SUBJECT: CORPORATE AND STATION STAFF ORGANIZATIONAL STRUCTURE (TAC NO. 66676)

RE: LIMERICK GENERATING STATION, UNIT 1

Amendment No. 10  
License No. NPF-39

SUPPORTING AMENDMENT NO. 10 TO FACILITY OPERATING LICENSE NO. NPF-39

# PHILADELPHIA ELECTRIC COMPANY NUCLEAR MANAGEMENT ORGANIZATION CHART

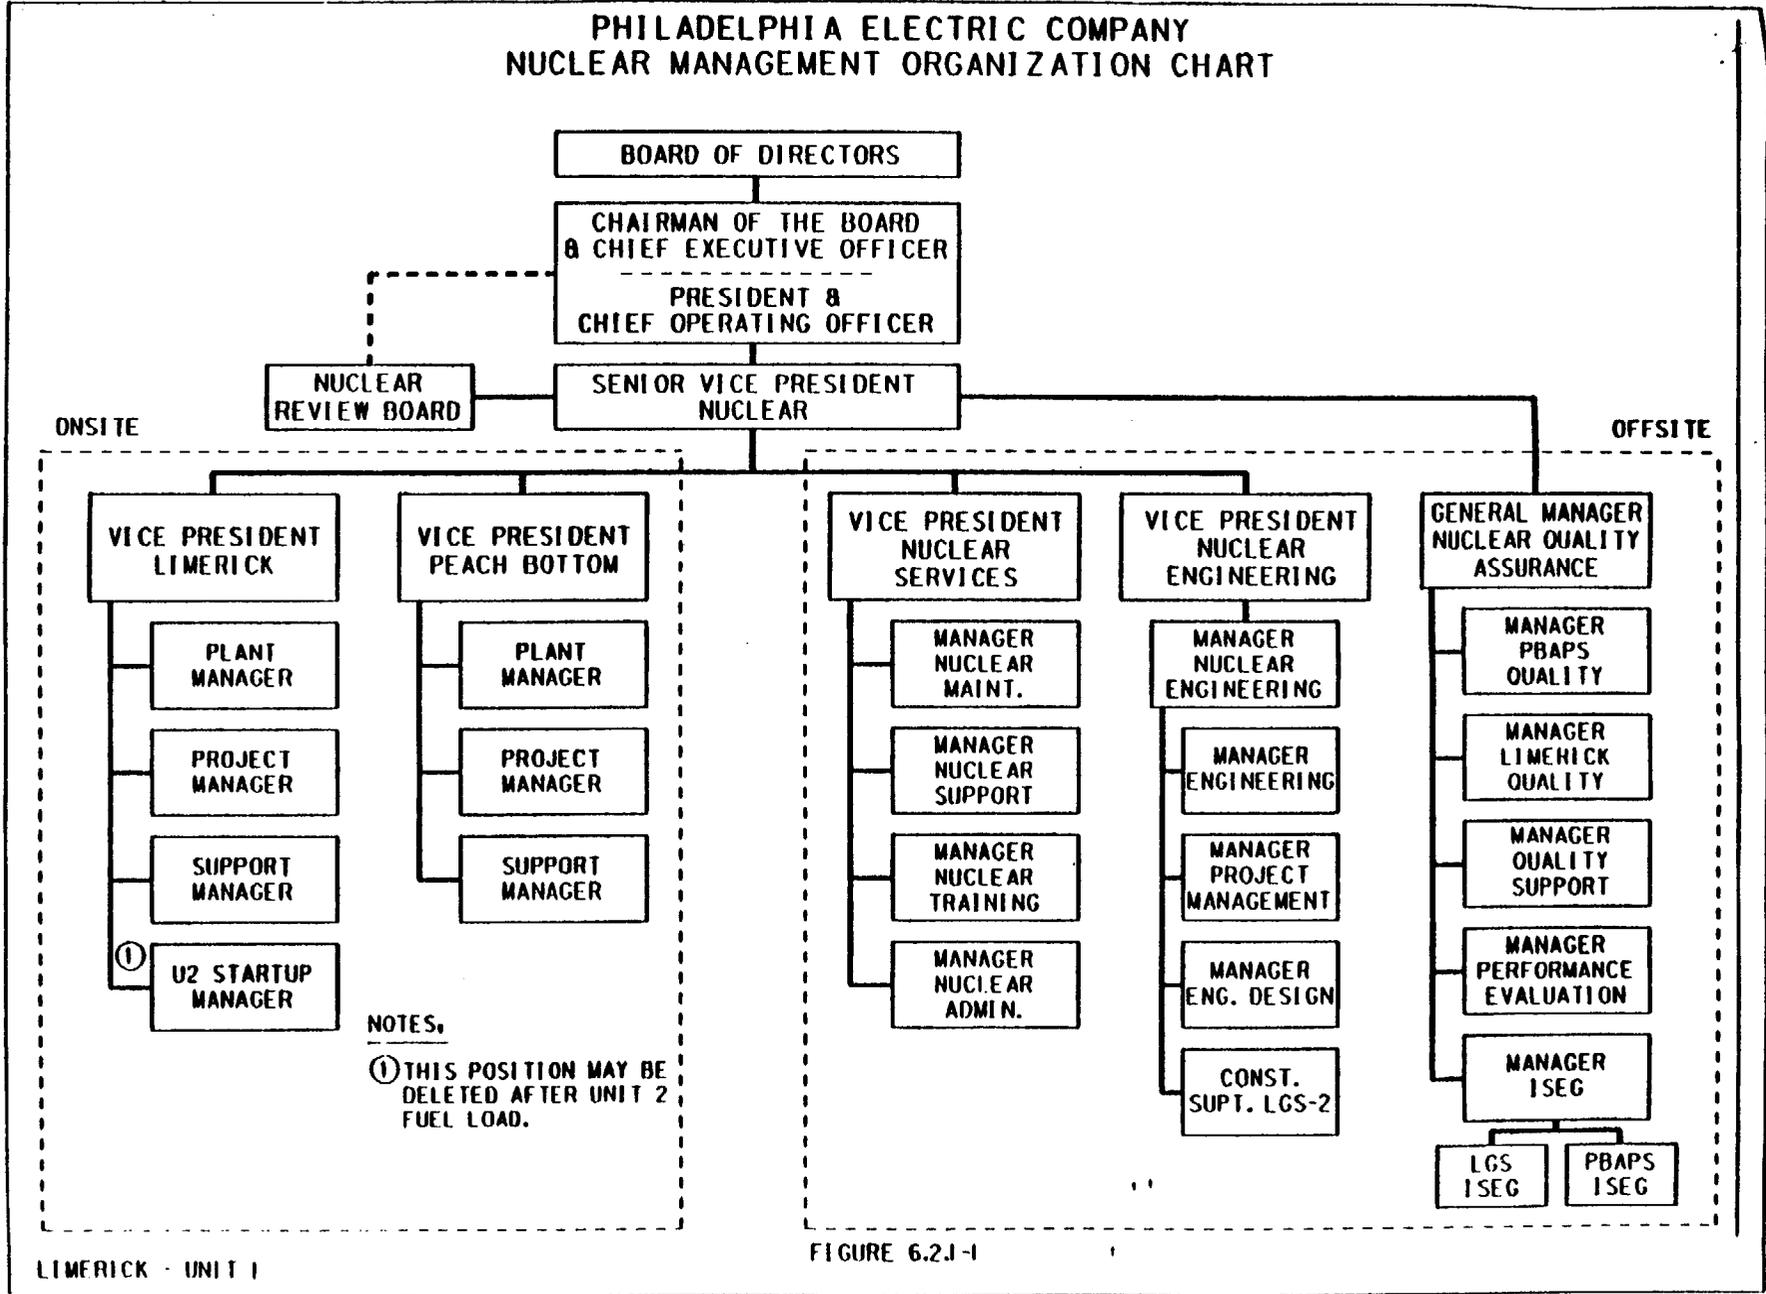
I. Offsite Management and Support Organization, Figure 6.2.1-1

PECo has established, within the corporate structure, a dedicated nuclear organization with direct management authority and responsibility over all aspects of nuclear operations, engineering, maintenance, and construction. The new nuclear organization will be headed by an Executive Vice President-Nuclear with nuclear responsibilities only. This organization has been formed by separating nuclear engineering, maintenance and other nuclear operations support activities from corresponding fossil and hydro production support activities and reassigning these resources to the newly established dedicated nuclear organization. The positions of Senior Vice President-Nuclear Power, Nuclear Production Manager, Superintendent-Nuclear Generation Division, Superintendent-Nuclear Services, and Manager-Nuclear Plant have been abolished and the functions under these positions have been reassigned within the new organization under the Executive Vice President-Nuclear. Revision I of the Plan for Restart included a change in the title of the senior nuclear executive to Executive Vice President-Nuclear. The new organization is shown in revised Technical Specification (TS) Figure 6.2.1-1. Reporting to the Executive Vice President-Nuclear are the Senior Vice President-Nuclear, Vice President-Nuclear Services, Vice President-Nuclear Engineering, General

Manager-Nuclear Quality Assurance, Vice President-Limerick and Vice President-Peach Bottom. In addition, the Nuclear Review Board (NRB) reports directly to the Executive Vice President-Nuclear.

The new office of Vice President-Nuclear Services has responsibility for nuclear service activities that support the station. Reporting to the Vice President-Nuclear Services are the Manager-Nuclear Support, Manager-Nuclear Maintenance, Manager-Nuclear Training, and Manager-Nuclear Administration. The Manager-Nuclear Support is responsible for licensing, fuel management, radiation protection, radioactive waste management, nuclear plant chemistry, emergency preparedness, nuclear plant security and the Operating Experience Assessment program.

The Nuclear Review Board (NRB) is responsible for providing independent review and audit of technical and managerial areas. Its composition is being revised to include outside nuclear executives.

We have reviewed the requested changes and found them acceptable as they meet the acceptance criteria of the appropriate parts of Section 13.1.1 of NUREG-0800, the Standard Review Plan.

FIGURE 6.2.2-1  
ORGANIZATION FOR CONDUCT OF PLANT OPERATIONS

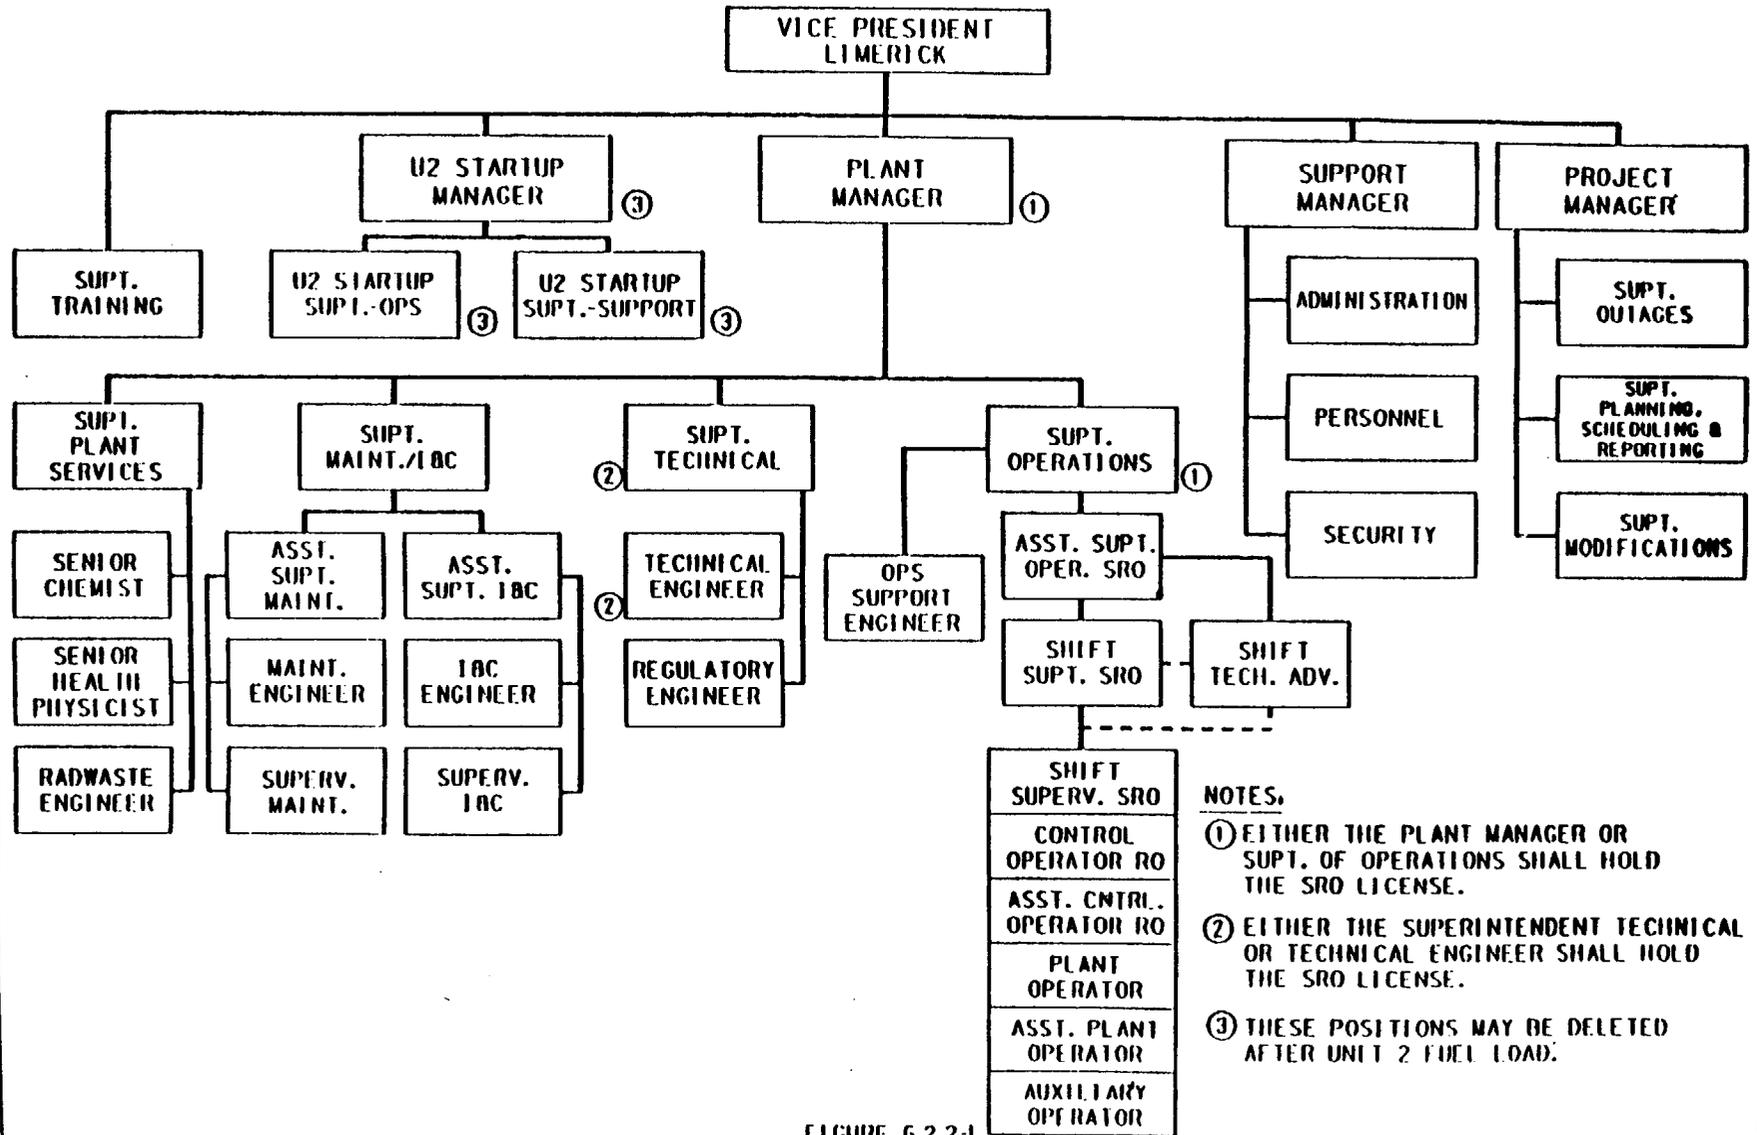
## II. Onsite Management Organization, TS Figure 6.2.2-1

PECo has established a new office of Vice President-Limerick Generating Station which will have overall control for the conduct of activities of all organizations at the Limerick site. The Vice President-Limerick is located at the Limerick site. PECO has reassigned previous functions and added new functions under a Plant Manager, Support Manager, Project Manager, Unit 2 Startup Manager and Superintendent-Training, who all report directly to the Vice President-Limerick.

The Plant Manager will be responsible for operating the plant safely, reliably, and efficiently in accordance with all applicable requirements. Reporting to the Plant Manager are the Superintendent Plant Services, Superintendent-Maintenance/Instrumentation and Controls, Superintendent Technical, and Superintendent Operations.

The Superintendent-Operations will be responsible for management oversight of shift operations. Reporting directly to the Superintendent-Operations are an Assistant Superintendent-Operations and an Operations Support Engineer. Reporting to the Assistant Superintendent-Operations are the six Shift Superintendents and the six Shift Technical Advisors. The Shift Superintendents manage the operations of the plant on their assigned shifts.

Either the Plant Manager or the Superintendent of Operations shall hold an SRO license. The present Superintendent has an SRO license and the new Plant Manager has completed the Limerick Station SRO Certification Program and the INPO Senior Nuclear Plant Managers Program. The Assistant Superintendent-Operations and the Shift Superintendents are required to have SRO licenses. Although not required, the Operations Support Engineer also holds an SRO license.
